<b>Settlement</b>	<b>Aberlour</b>
<b>Site Address</b>	Braes of Allachie
<b>Ref Number</b>	R5, R2A
<b>Bid Summary</b>	Allocation of an additional two sites at Braes of Allachie. Site A for 50 houses and Site B for 2 houses.
<b>Site Description</b>	Site A is an irregular shaped site of 3.19 ha on the slopes of the Braes of Allachie. The land is characterised as rough agricultural/ grazing land. Site B is a small almost rectangular piece of ground immediately adjacent to the existing R2 designation and is a relatively flat area of agricultural grazing ground. Access to both sites is proposed directly off the public road.
<b>Greenfield/ Brownfield</b>	Greenfield
<b>Current Zoning</b>	Countryside

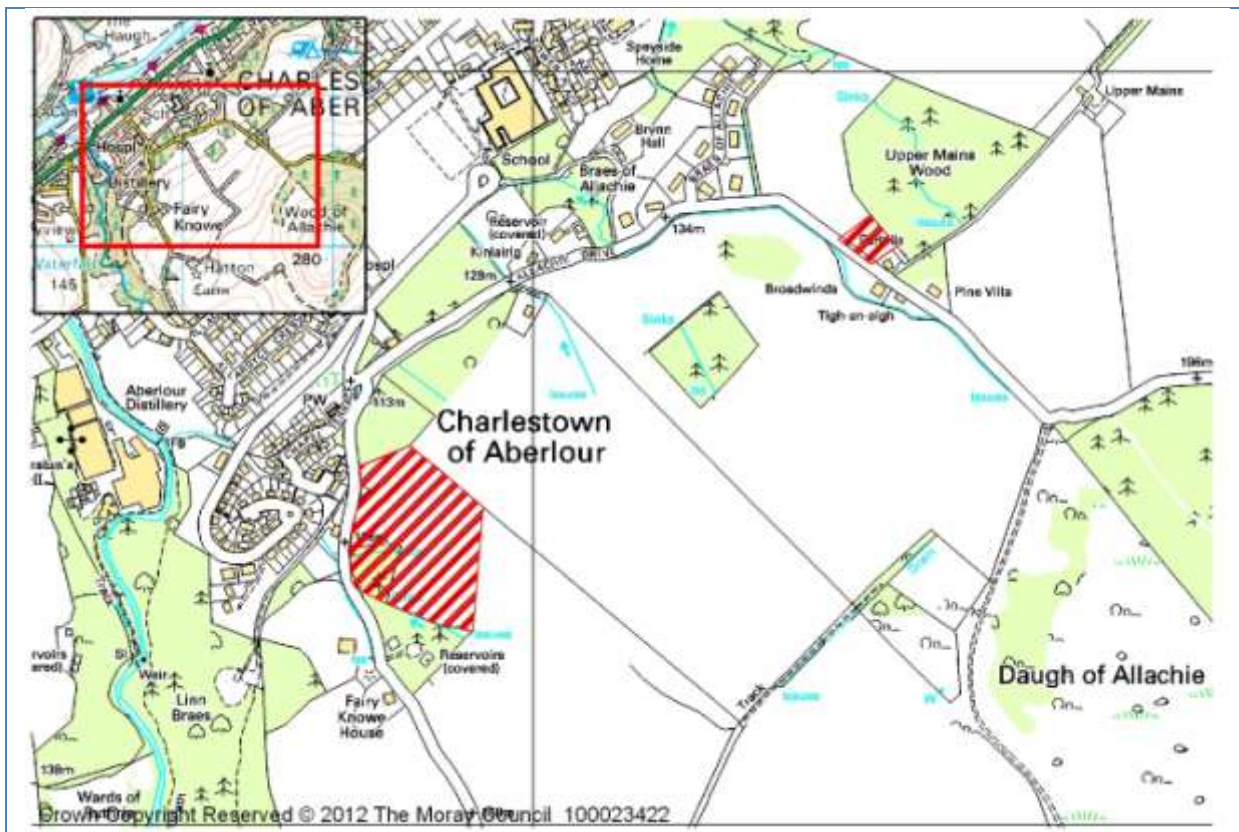
<b>Transportation</b>	The whole Braes of Allachie area is accessed via a long winding and narrow road with few passing places and an extremely tight bend where it joins Chapel Terrace. The development of existing designations at Braes of Allachie requires significant improvements to existing infrastructure and a Transport Assessment. The current road infrastructure is not suitable for any development until the issues have been resolved. The addition of these sites (Area A and B) without a second access and
-----------------------	---

<p>the existing constraints, which the applicant/owner of the existing designation has not been able to overcome, make these new sites virtually undeliverable and absolutely unacceptable in transportation terms. Whilst site B (for only 2 units) is less onerous in transportation terms, no further development should take place from this road until the issues at the junction with Chapel Terrace are resolved and any other improvements required for development proposals have been provided.</p>
<b>Planning History</b>	<p>Site A – 07/00588/OUT – Outline to erect 1 dwellinghouse at Daugh of Allachie – Application withdrawn.  07/01794/OUT – Outline to erect 1 dwellinghouse on site at Daugh of Allachie – Refused as the development is located immediately outwith the settlement boundary and would lead to the erosion in the distinction between the built up area and the countryside. The development does not adopt a dispersed pattern of development, detracting from the rural character of this part of the countryside and set a precedent for other similar applications to be submitted in the locality, which would be contrary to development plan policies.</p> <p>Site B 03/01671-1672/OUT – Erecting dwellings at Plots 1 &amp; 2 Braes of Allachie - The proposal would not be positioned sensitively along with an established group of buildings, would not reflect the established settlement pattern or blend unobtrusively with its surrounds and would involve a build-up of residential development such that the character would become more that of a suburban cluster of buildings.</p>

<b>Environmental Health</b>	<p>No comments have been made in terms of noise or contaminated land issues.</p>
<b>Flooding</b>	<p>SEPA - Site A – FRA needed if watercourse to be affected by development, however, if avoided and buffer provided, FRA probably not needed. Development proposals should include buffer zones to allow for the development of natural processes. Careful consideration of surface water drainage is required due to surface water flooding of sewage system. Flood Team - There is no known fluvial flood risk at this location. Surface water/overland flow will need to be addressed by the developer. There is a Flood Prevention Scheme below this location which is not designed to take surface flow from these fields and as a result surface water flooding can occur. SUDS and construction phase surface water management required so as not to have adverse impact on existing properties. Developer to consider the impact that this development may have on existing FPS as there is a likelihood of debris being washed into the FPS especially during the construction phase.</p>

<b>Landscape</b>	<p>The sites are on the slopes of Braes of Allachie on the southern edge of Aberlour. The sites occupy an elevated position but are separated from the bulk of the existing settlement by the steep wooded slopes. Site A is promoting development on progressively steeper land that is not considered appropriate for development. The ENV 6 designation and proposed structural planting</p>

effectively create an outer limit for the settlement edge. Site A would promote development beyond this. Site B is nestled between R2 and an existing house and should be accommodated without impact on the landscape.
<b>Biodiversity/Natura</b>	Site A – River Spey SAC – sufficient information will be required at the applications stage to confirm that adequate protection measures are able to be implemented to protect the water environment. Potential to include housing and surface design ideas to reduce surface water run off. Optimise the extent of green areas that can absorb rainwater. Potential to introduce native tree planting to enhance residential area and encourage birdlife.
<b>Water/Waste water</b>	Site A & B – Proposed development may have minor implications for the Burn of Aberlour and River Spey which already have point source pollution from sewage. Available capacity at STW may be an issue. Site B – May have minor implications for Burn of Aberlour and River Spey which already have point source pollution from sewage. Scottish Water - Water supply Badentinan 74/WWT Aberlour 30. Site A has a 150mm water main running through edge of site.

<b>Cultural Heritage</b>	Taking into consideration the topography of the site there is potential for archaeological remains within these bid areas. Site A - An archaeological evaluation should be undertaken prior to development commencing within this bid site. Site B - No archaeological mitigation would be required within this bid site.
<b>Overall SEA Assessment</b>	The site is in close proximity to the River Spey SAC however there is no significant environmental impact identified.
<b>Overall Planning Assessment</b>	Site A –is unacceptable in on roads grounds. The development is also considered inappropriate in landscape terms as it promotes development beyond an outer limit to the settlement that will be created when the long designation is implemented. Site B – the site is for an additional two houses, this could be accommodated within the R2 designation or considered for development in its own right. The uptake of housing land in Aberlour has been limited and many sites are constrained by various technical issues impeding take up of sites. There may be a case for the identification of a small site to meet local demand. Transportation consider ANY new development from Allachie Drive to be unacceptable until the visibility issues at the junction of Allachie Drive with Chapel Terrace have been delivered and thereafter improvements to the road width and provision of footways on Allachie Drive have been delivered at the appropriate levels of development commencing ( in order to provide adequate provision for non motorised access to the development).

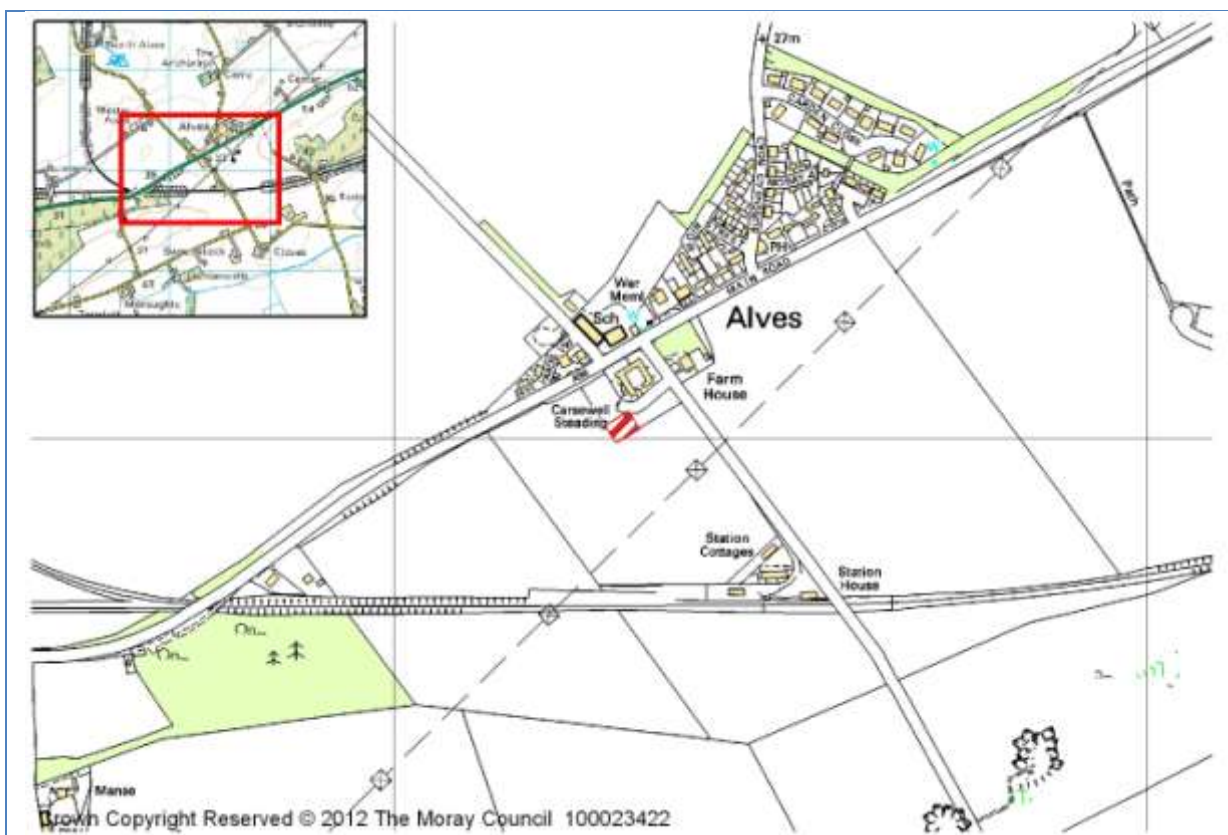
<b>Transportation</b>	No comments
<b>Planning History</b>	R1 has consent for conversion from farm steading to residential use and has been developed.
<b>Environmental Health</b>	No comments
<b>Flooding</b>	Not at risk of flooding

<b>Landscape</b>	No Comments
<b>Biodiversity/Natura</b>	No Comments
<b>Water/Waste water</b>	No comments
<b>Cultural Heritage</b>	No comments
<b>Other</b>	<a href="#">Click here to enter text.</a>
<b>Overall SEA Assessment</b>	No significant environmental issues arising
<b>Overall Planning Assessment</b>	The proposal represents a logical extension to site R1.

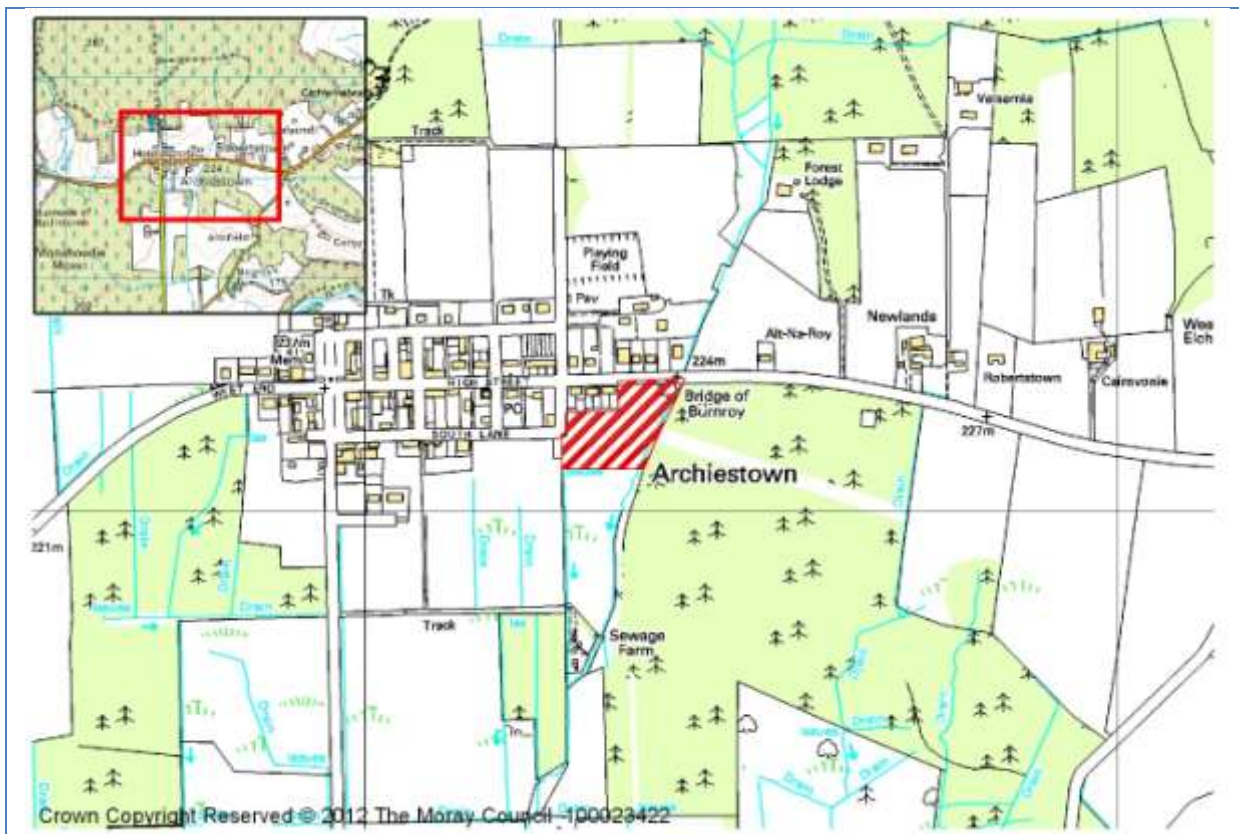
<b>Transportation</b>	Access onto the B9012 must achieve required visibility splays of 2.4m (minimum) X 70 m to the west and 2.4 m (minimum) X 160m to the east which requires land outside the bid site. Extension of footway along site frontage and extension of street lighting is also required.
<b>Planning History</b>	No recent planning history on the R1 site.
<b>Environmental Health</b>	No comments raised in terms of contaminated land or noise issues.

<b>Flooding</b>	SEPA - FRA needed if watercourse to be affected by development, however, if avoided and buffer provided, FRA probably not needed. The watercourse is steep so not likely to be a major problem on this site. Flood team - No known fluvial flood risk at this location.
<b>Landscape</b>	The site is relatively flat and sits at a lower level than the public road. There is a backdrop of mature coniferous trees to help the development integrate. Given the site's location on the eastern approach, consideration should be given to landscaping to soften an otherwise hard edge to the village.
<b>Biodiversity/Natura</b>	River Spey SAC – sufficient control of surface water run off during construction required to avoid impacts on the SAC interests. The watercourse should be provided with a buffer zone. Watercourse could be used by otters very occasionally but this is unlikely to be an issue in this case. Potential to include housing and surface design ideas to reduce surface water run off. Optimise the extent of green areas that can absorb rainwater. Potential to introduce native tree planting to enhance residential area and encourage birdlife.

<b>Water/Waste water</b>	Development proposals should include buffer zones to allow for the development of natural processes. Potential STW capacity issue. Water supply Badentianan indicative capacity 74 units. Waste water treatment Archiestown available capacity 28 units. Flood Team - SUDS and construction phase surface water management plan required.
<b>Cultural Heritage</b>	No archaeological mitigation would be required within this bid site. The site is in close proximity to the Archiestown conservation area and there is specific reference to the inclusion of lanes to reflect the existing grid pattern of the village.
<b>Overall SEA Assessment</b>	No issues that are considered to have a significant environmental impact.
<b>Overall Planning Assessment</b>	The site is allocated within the current local plan and it is considered the most suitable site for development and designed to reflect the character and appearance of the village. The site is considered capable of being extended to accommodate a further 5 – 6 houses.

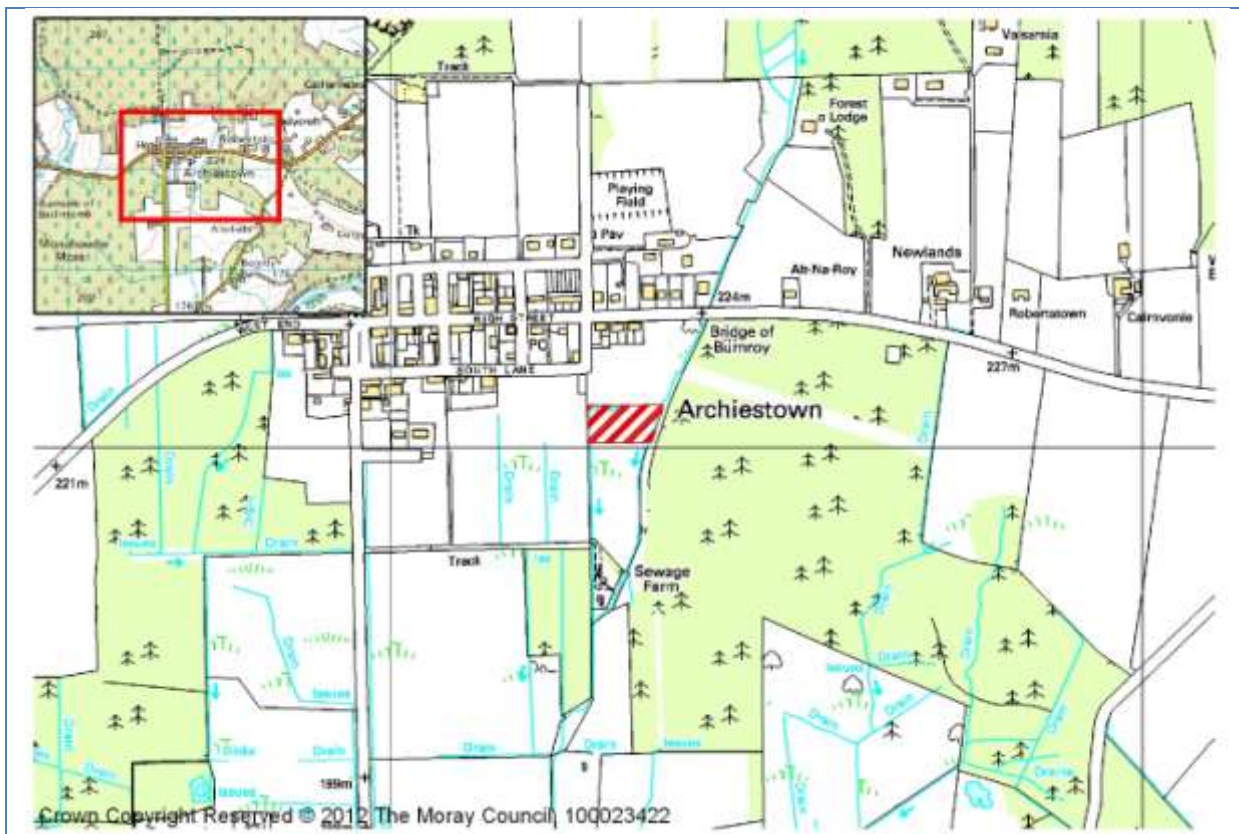
<b>Transportation</b>	Access to this site would be through R1 Archiestown onto the B9012 must achieve required visibility splays of 2.4 m (minimum) X 70m to the west and 2.4m (minimum) X160m to the east which requires land outside of the bid site. Extension of footway along site frontage and extension of street lighting also required.
<b>Planning History</b>	No planning history on the site.
<b>Environmental Health</b>	No comments raised in terms of contaminated land or noise.

<b>Flooding</b>	The site is not shown as flooding on the SEPA indicative flood maps. Flood Team - There is no known fluvial flood risk to this site. Drainage Impact Assessment may be required to ensure that there is no increased flood risk to neighbouring property. SUDS required as part of development.
<b>Landscape</b>	The land is relatively flat before sloping gently downwards from north to south. The new development will be viewed in the main in the context of the village townscape. Consideration could be given to landscaping to soften the southern edge of the site when approaching from Carron.
<b>Biodiversity/Natura</b>	Drainage issues will be a relevant consideration at the plan stage. The site could include wet ground and problems with ground and surface water. Nearby ditches drain to the River Spey SAC so it will be important to ensure that measures can be taken to ensure water quality is not affected downstream.

<b>Water/Waste water</b>	Water supply Badetinan – indicative capacity 74 units. Waste water treatment Archiestown – indicative capacity 28 units.
<b>Cultural Heritage</b>	The site is in close proximity to the Archiestown conservation area. There is reference within the existing designation to incorporating lanes into the development and retaining the traditional grid pattern.
<b>Overall SEA Assessment</b>	No issues identified that would significantly impact on the environment.
<b>Overall Planning Assessment</b>	Part of this area of land is already designated for housing in the Moray Local Plan 2008. The additional land proposed for inclusion is of a similar character and appearance. The site offers the opportunity to respect the traditional grid layout of the village.
<b>Other</b>	Energy is an important consideration for areas off the mains gas network. The layout, orientation and design of the development should maximise opportunities for passive solar gain and the installation of renewable technologies.

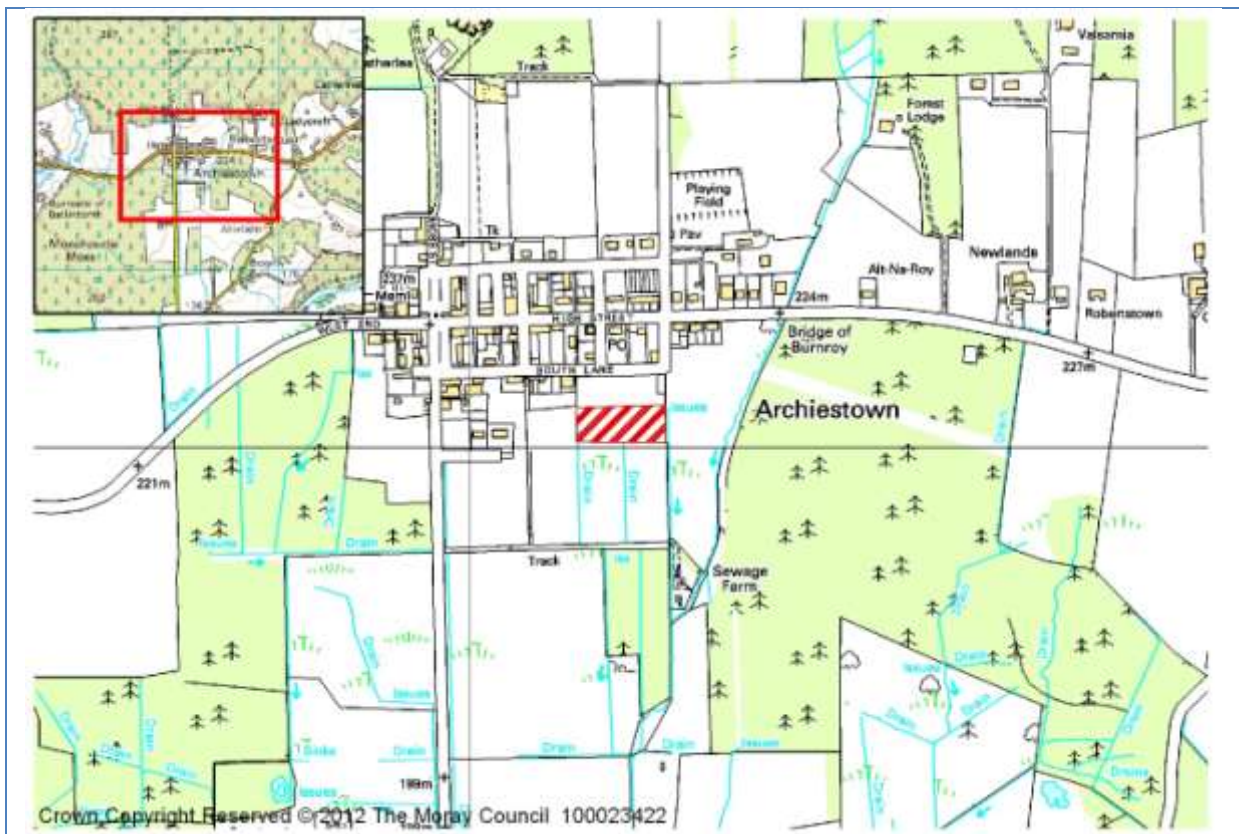
<b>Transportation</b>	Access to site is through the existing R4 Archiestown designation, extension of existing “grid” road network, connection to other adjacent sites is advised.
<b>Planning History</b>	No recent planning history on the site.
<b>Environmental Health</b>	No comments raised in terms of contaminated land or noise.

<b>Flooding</b>	The site is not shown as flooding on the SEPA indicative flood maps. Flood team – There is no known fluvial flooding.
<b>Landscape</b>	The land is relatively flat before sloping gently downwards from north to south. The new development will be viewed in the main in the context of the village townscape. Consideration could be given to landscaping to soften the southern edge of the site when approaching from Carron.
<b>Biodiversity/Natura</b>	Drainage issues will be a relevant consideration. The sites could include wet ground and problems with ground and surface water. Nearby ditches drain to the River Spey SAC so it will be important to ensure that measures can be taken to ensure water quality is not affected.
<b>Water/Waste water</b>	Water supply Badetinan – indicative capacity 74 units. Waste water treatment Archiestown – indicative capacity 28 units.
<b>Cultural Heritage</b>	The site is in close proximity to the Archiestown conservation area. There is reference within the existing designation to incorporating lanes into the development and retaining the traditional grid pattern. There are no archaeological sites within the identified site. No archaeological mitigation would be required for this site.

<b>Overall SEA Assessment</b>	No issues identified that would significantly impact on the environment.
<b>Overall Planning Assessment</b>	Part of this area of land is already designated for housing in the Moray Local Plan 2008. The additional land proposed for inclusion is of a similar character and appearance. The site offers the opportunity to respect the traditional grid layout of the village.
<b>Other</b>	Energy is an important consideration for areas off the mains gas network. The layout, orientation and design of the development should maximise opportunities for passive solar gain and the installation of renewable technologies.

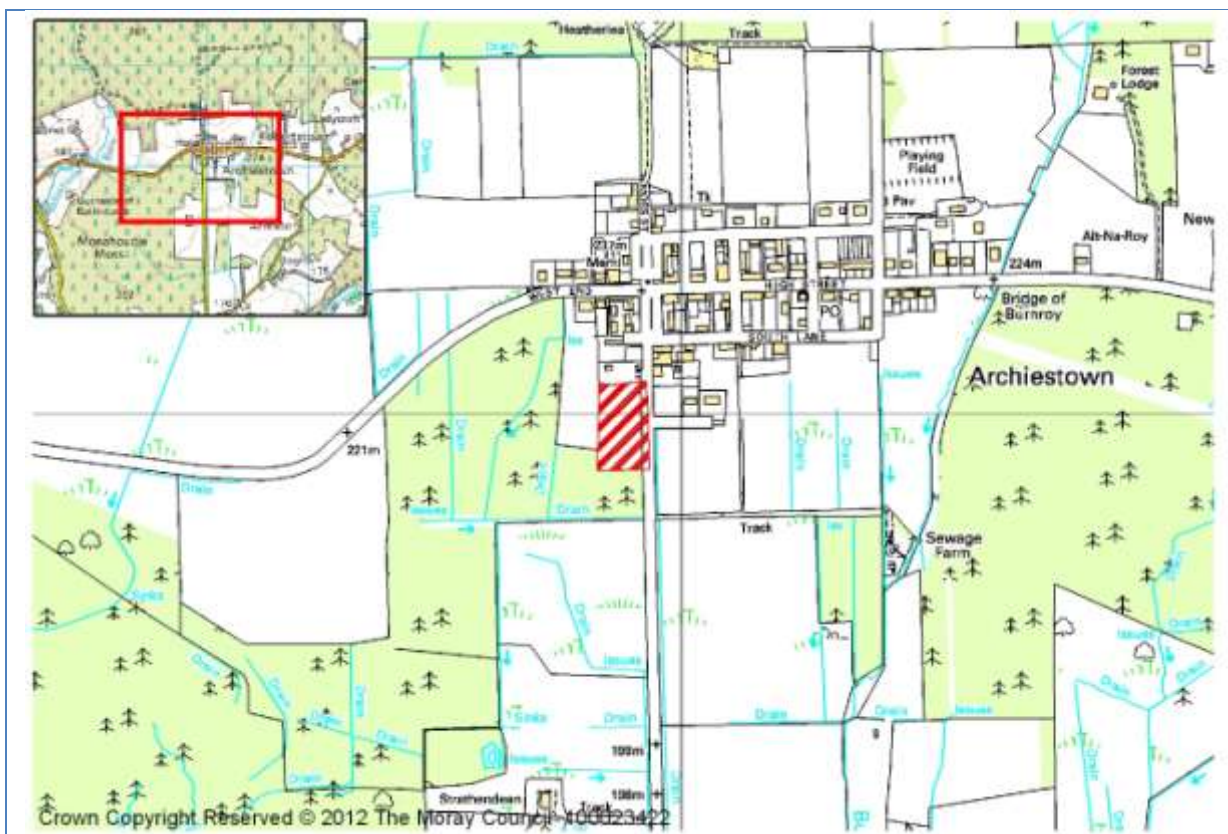
<b>Transportation</b>	Footway connections required northwards from site to the Square. Visibility splays may require third party land, minimum required 2.4m X 70m to north, 2.4m X 60m to the south.
<b>Planning History</b>	No planning history.
<b>Environmental Health</b>	No comments made in respect of contaminated land or noise.

<b>Flooding</b>	The site is not shown as flooding on the SEPA indicative flood maps.
<b>Landscape</b>	The site sits at a lower level than the existing housing and slopes from north to south. There is commercial woodland providing a backdrop to the site. This should be supplemented with planting within the site so the development blends in sensitively.
<b>Biodiversity/Natura</b>	Drainage issues will be a relevant consideration at the plan stage. Sites could include wet ground and problems with ground and surface water. Nearby ditches do drain to the SAC so it will be important to ensure that measures are taken to ensure water quality is not affected downstream.
<b>Water/Waste water</b>	Water supply Badentinan – indicative capacity 74 units. Waste water treatment – Archiestown 28 units.
<b>Cultural Heritage</b>	The site is in close proximity to the Archiestown Conservation Area and this should be reflected in the quality of design on site. There are no known archaeological sites within the identified site. No archaeological mitigation would be required for this site.

<b>Overall SEA Assessment</b>	No issues considered to have a significant environmental impact.
<b>Overall Planning Assessment</b>	The site is a natural extension to Archiestown where development has evolved along roads and lanes in the village. The site is enclosed to a certain extent by a plantation of conifers that help the development to integrate sensitively.
<b>Other</b>	Energy is an important consideration for areas off the mains gas supply network. The layout, orientation of the development should be designed to maximise the opportunities for solar passive gain and the installation of renewable technologies.
